Modifications Report – December 2014
 Review of TfNSW’s Modifications Report with regards to UNSW interests.

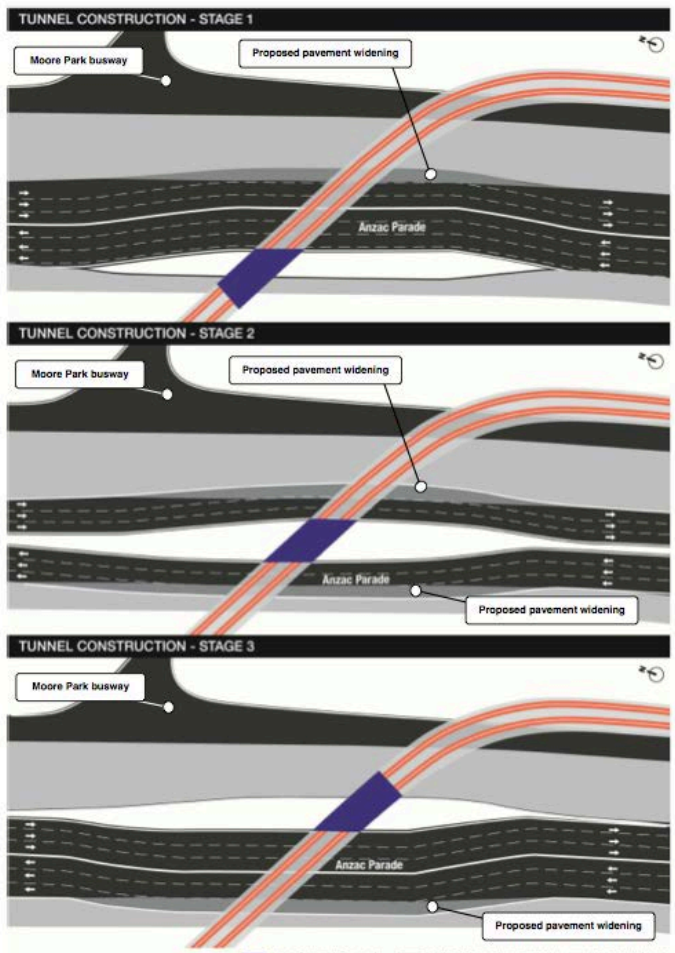
<ul style="list-style-type: none">Adopting a conservative 2% p.a. growth rate for the campus population (which has grown at 5% p.a. since 2007) and retaining the existing proportion of public transport users (60%), light rail patronage for the campus stops will increase by 15% by 2021.Assuming a peak hour capacity (at opening in 2021) of 3,495 pax per hour (7.5 LRV per hour x 466 pax per LRV) per line, UNSW passengers will utilise up to 90% of the capacity of the services.All the above figures are for UNSW staff and students only. Additional passengers already on each LRV will reduce their capacity to take on passengers at the UNSW stops. Passengers from the surrounding areas using the UNSW stops will increase crowding on the stops and at the access points to the stops. <div><p>UNSW - By Stop Boarding & Alighting Passenger Volumes Per 15 Minutes (2014)</p><p>UNSW - Total Boarding & Alighting Passenger Volumes Per 15 Minutes (2014)</p><p>UNSW - Total Boarding & Alighting Passenger Volumes Per Rolling Hour (2014)</p></div> <p>UNSW is concerned that although additional services may be provided to cater for the additional growth in patronage, the size of the stops have not been designed to cater for this expected growth.</p>	2014	Type	Maximum 15 Minute Volume	Maximum Hourly Volume	Daily Volume	Anzac Parade	Alighting	930	2781	12516	Boarding	1013	2719	14607	High Street	Alighting	569	1830	8124	Boarding	238	584	3792	Total (both stops)	Alighting	1437	4611	20640	Boarding	1166	3187	18399
2014	Type	Maximum 15 Minute Volume	Maximum Hourly Volume	Daily Volume																																
Anzac Parade	Alighting	930	2781	12516																																
	Boarding	1013	2719	14607																																
High Street	Alighting	569	1830	8124																																
	Boarding	238	584	3792																																
Total (both stops)	Alighting	1437	4611	20640																																
	Boarding	1166	3187	18399
